SEWAGE DISPOSAL SYSTEM

MARYLAND STATE DEPARTMENT OF HEALTH*

SUBDIVISION Roxbury ROAD 4095 Roxmill Court LOT 10

PLOT PLAN

#7 SOIL PROFILE

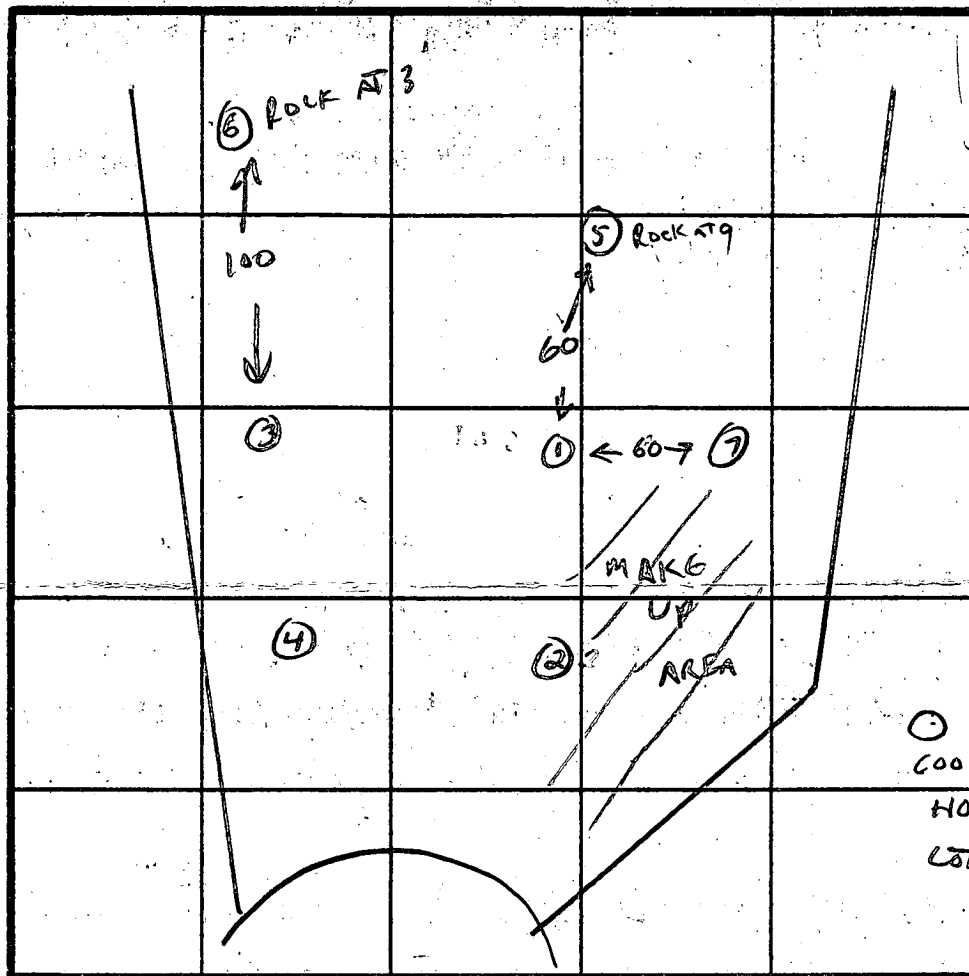
REASONS FOR REJECTION OR HOLDING RETEST OK - NEED NEW PLOT PLAN, HOUSE SITE

BEFORE WRITING SPECS. 11-28-83 C. Wilman

APPROVED BY C. Wilman FOR TRENCHES DATE 11-17-83
NEW LAYOUT APPROVED C. Wilman TRENCHES DATE 1-18-84

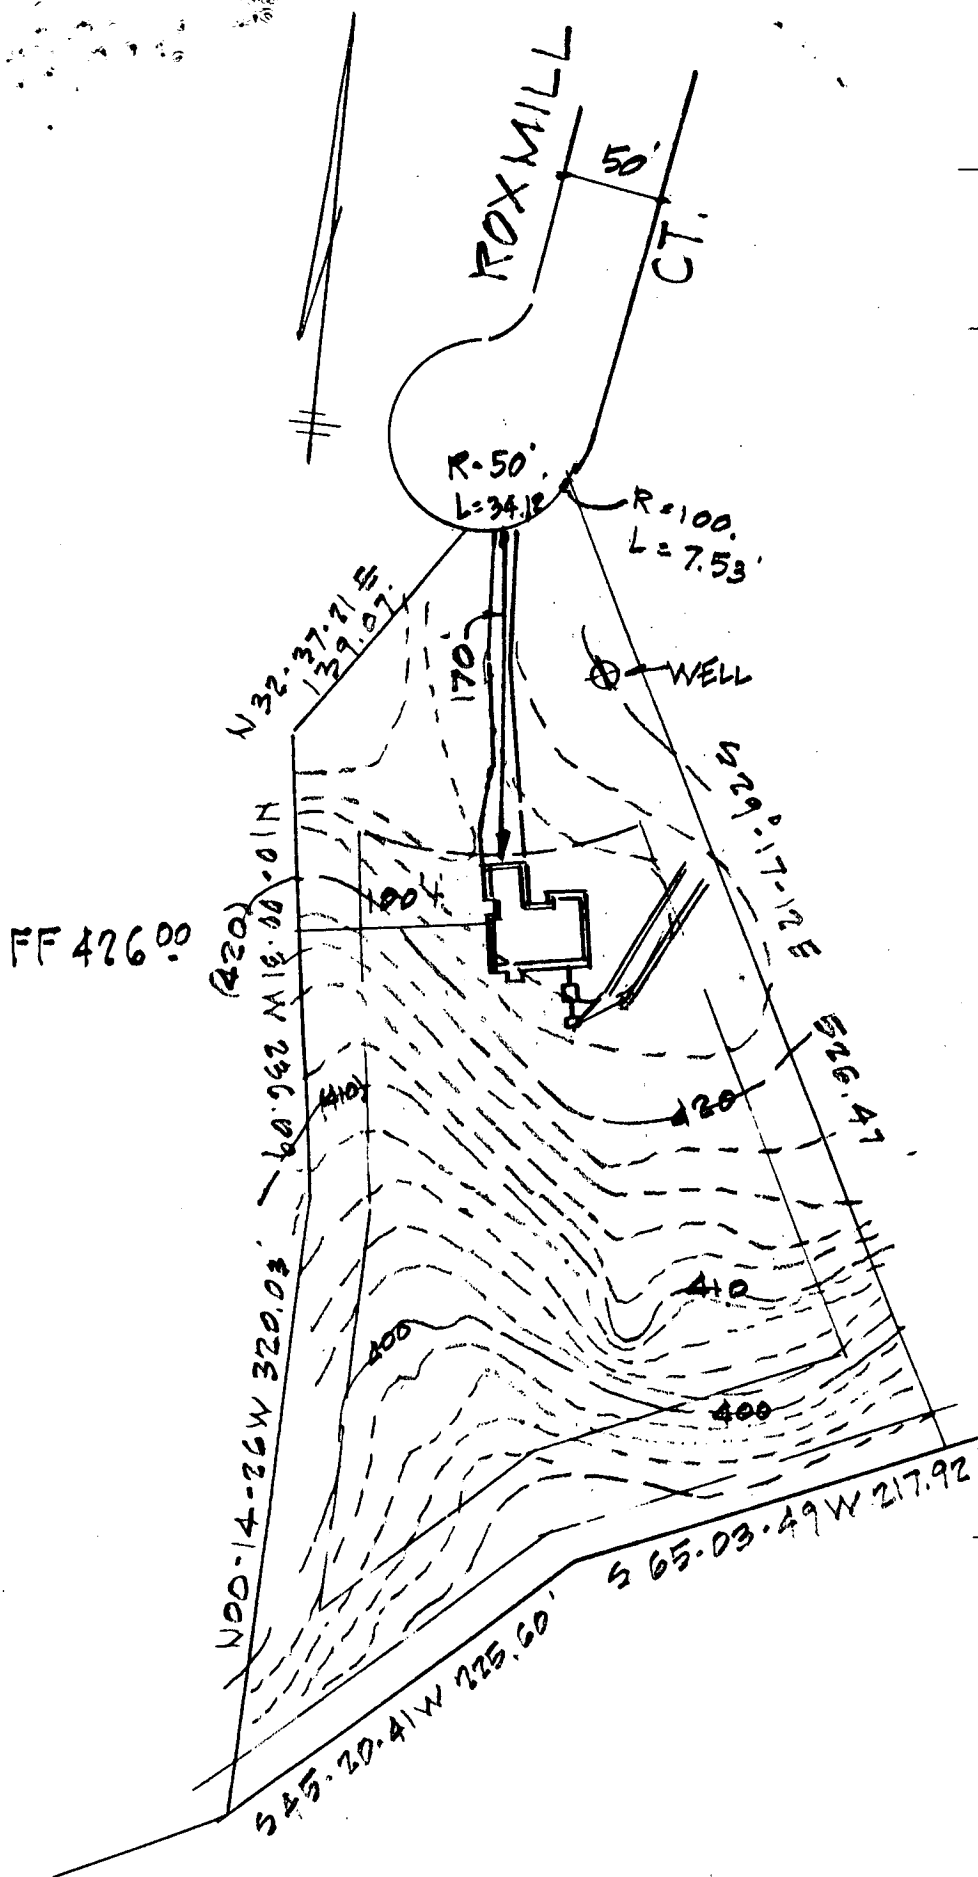
5/18/84 Sketch O.K.
but manhole on
septic tank required
J.F.
